**Approved baseline and monitoring methodology/
methodological tool clarification response form
(Version 02.0)**

Date and number of Panel/ WG meeting:	3–5 February 2014, SSC WG 43
Title/Subject of the request for clarification:	Clarification on the penalty in case of instrument breakdown when calibration was overdue
Reference number of the request for clarification:	SSC_696
Exact reference (number, title and version) of the methodology or methodological tool to which the request for clarification applies:	AMS-III.H Methane recovery in wastewater treatment Version 16.0
Fast track or Regular track:	<input type="checkbox"/> Fast track <input checked="" type="checkbox"/> Regular track

Summary of the request for clarification

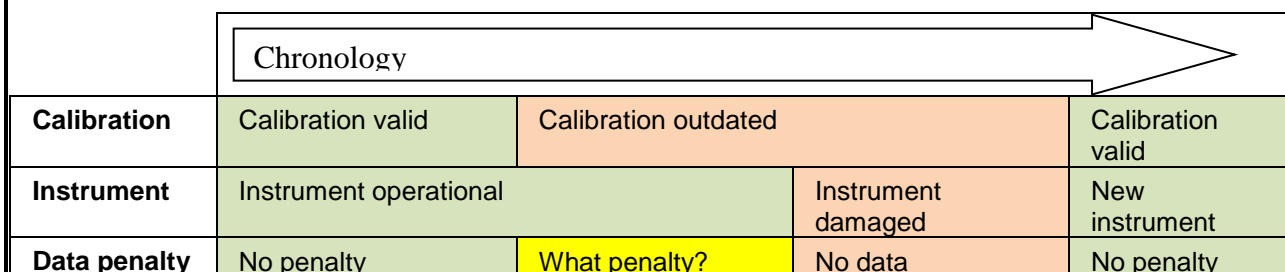
We would like to seek your clarification regarding the following case:

If an instrument breaks down permanently while its calibration is overdue, what penalty should be applied to the affected data? In such a case, as the instrument beyond repair, its measurement error cannot be tested.

Should the manufacturer maximum error be applied as penalty to the data?

The diagram below shows the event chronology:

The SSC WG would like to clarify that as AMS-III-H does not offer provisions for the use of non-calibrated meters, the provisions in section 9.4.4 of the "Clean development mechanism validation and verification

standard" shall apply. Furthermore, the "Clean development mechanism project standard" and the "Clean development mechanism validation and verification standard" do not offer provisions for the situation described in this clarification. Therefore, with the information available, the project proponents shall apply a conservative value of 0 per cent methane, and may not claim emission reductions for methane destruction.

The project proponents may apply for validation of post registration changes as per section 9.5 of the "Clean development mechanism validation and verification standard".
